<b>Title - Sujet</b> Rénov. majeure-Réseaux hydraul.	
<b>Solicitation No. - N° de l'invitation</b> EF944-161961/A	<b>Amendment No. - N° modif.</b> 001
<b>Client Reference No. - N° de référence du client</b> R.078727.001	<b>Date</b> 2016-01-21
<b>GETS Reference No. - N° de référence de SEAG</b> PW-\$MTC-255-13673	
<b>File No. - N° de dossier</b> MTC-5-38283 (255)	<b>CCC No./N° CCC - FMS No./N° VME</b>
<b>Solicitation Closes - L'invitation prend fin</b> <b>at - à 02:00 PM</b> <b>on - le 2016-02-03</b>	<b>Time Zone</b> Fuseau horaire Heure Normale du l'Est HNE
<b>F.O.B. - F.A.B.</b> <b>Plant-Usine:</b> <input type="checkbox"/> <b>Destination:</b> <input checked="" type="checkbox"/> <b>Other-Autre:</b> <input type="checkbox"/>	
<b>Address Enquiries to: - Adresser toutes questions à:</b> Desforges, Julie	<b>Buyer Id - Id de l'acheteur</b> mtc255
<b>Telephone No. - N° de téléphone</b> (514) 496-3413 ( )	<b>FAX No. - N° de FAX</b> (514) 496-3822

## ADDENDUM NO. M-1

Project: Dairy and Swine Research and Development  
Centre – Major renovation of the hydraulic  
heating and cooling network – Phase 1 –  
Section "Regulation" – TPSGC :  
R.078727.001

Description: Central management softwar

**CONTROL VALVE CARATERISTICS**  
**SEE SPECIFICATIONS SUBSECTION 25 30 02**

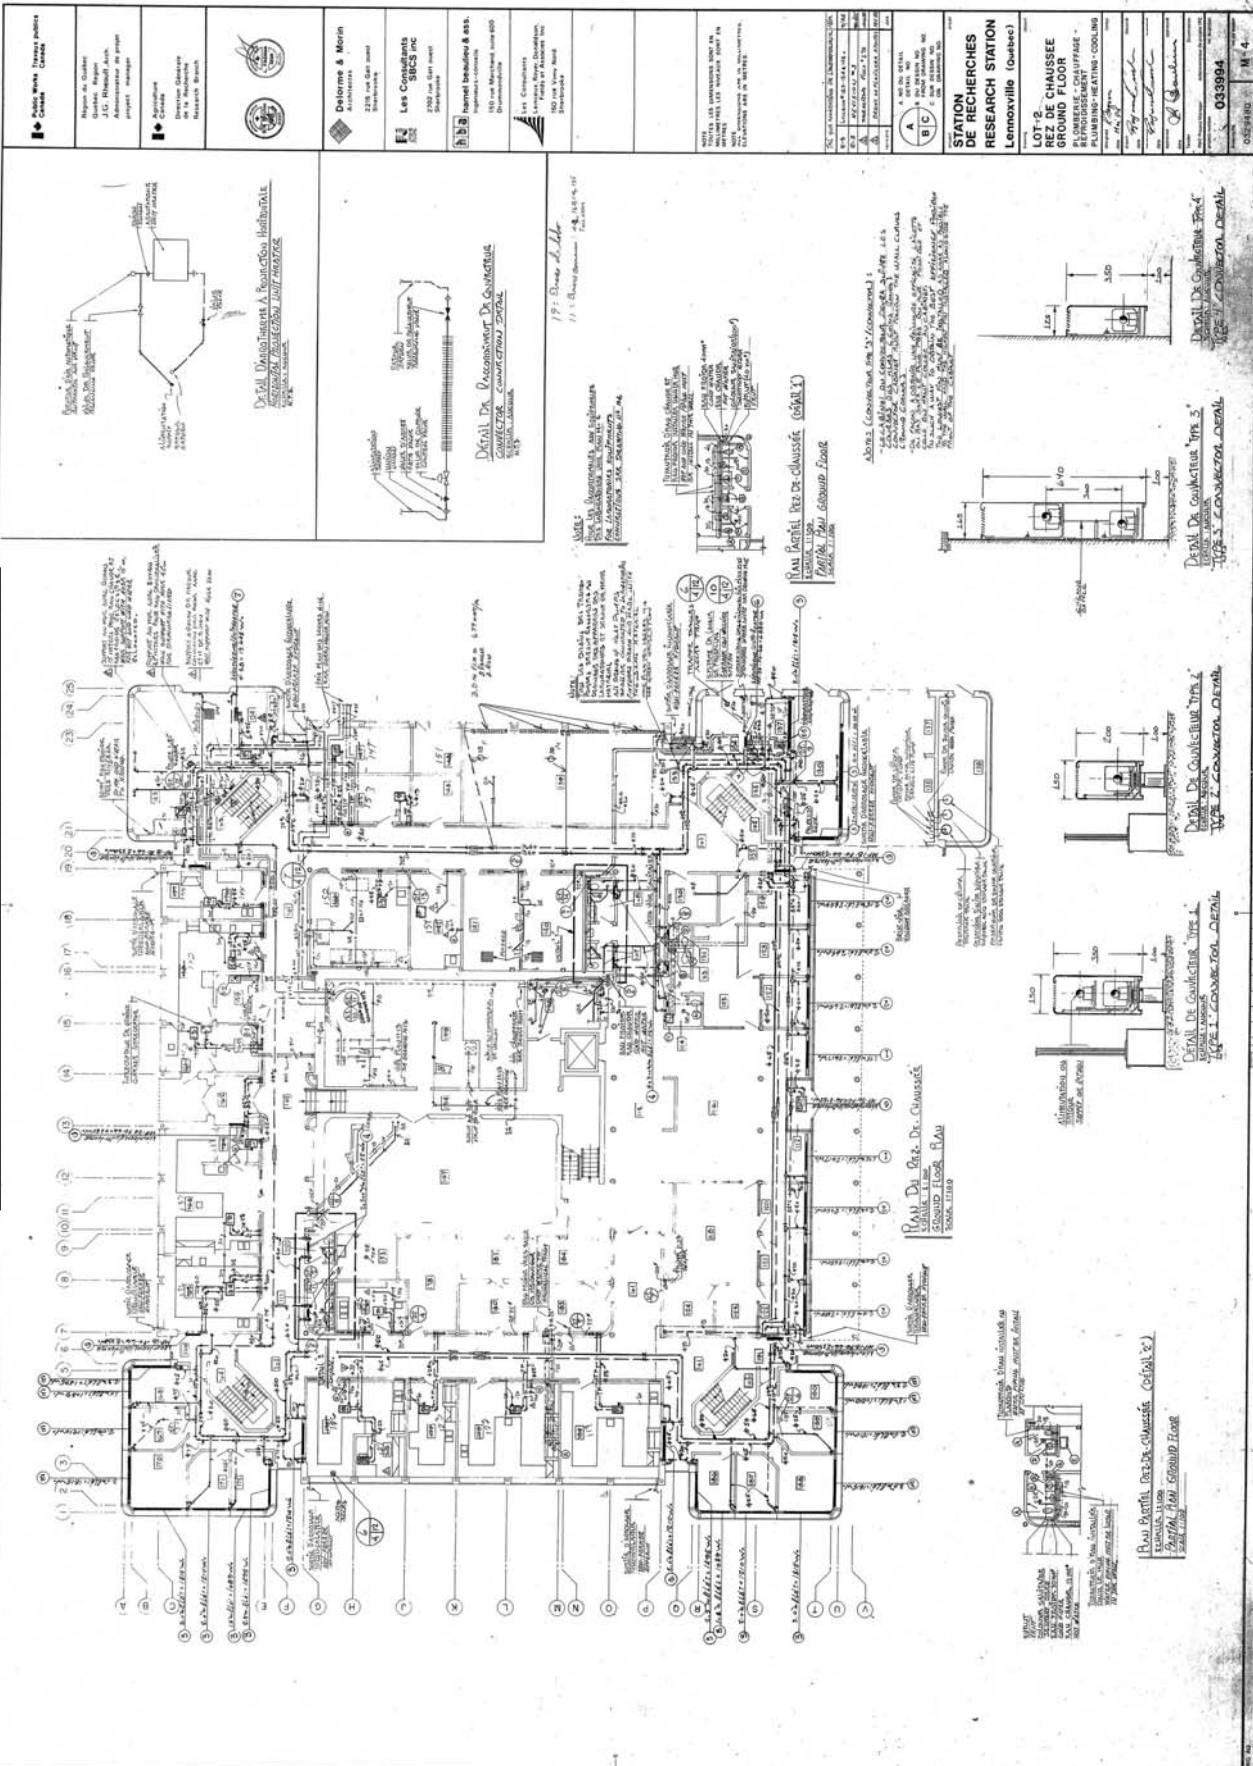
- 3.1 Clarification in requirements of centralized management software.
  - 3.2 Adding the specification of control valve EGL-DV-C.
  - 3.3 Emission of existing ventilation and heating drawings. These drawings are issued for information purposes only and should not be considered as up to date installation plans.

IDENTIFICATION	FLOW Usqpm	CV	DIAMETER INCH	ACTUATOR	VALVE				WPD kPa (psig)	QUANTITY	REMARKS
					TYPE	MODEL	N.O.	N.C.			
EGL-DV-REF1 et EGL-DV-REF2	-	461	3	BRAY S.70	DV	Bray	X	-	-	2	Pipe size diameter
EGL-DV-REF3	-	461	3	BRAY S.70	DV	Bray	X	-	-	1	Pipe size diameter
EGL-DV-ECH	26.6	16	1.25	SSC modulating 0-10V	DV	Powermite	X	-	2.70	1	Pipe size diameter
EBT-TV-I2	52.0	25	1.5	SSC modulating 0-10V	TV	Powermite	-	-	4.32	1	Pipe size diameter
EMT-DV-I	-	461	3	BRAY S.70	DV	Bray	-	X	-	2	Pipe size diameter
EGL-DV-C	90.0	16	1.25	Electric modulating SK serie	DV	Flowrite	-	X	31.60	1	-
<b>NOTES:</b> N.O. = NORMALLY OPEN N.C. = NORMALLY CLOSED TYPES: DV = TWO WAY TV = THREE WAY
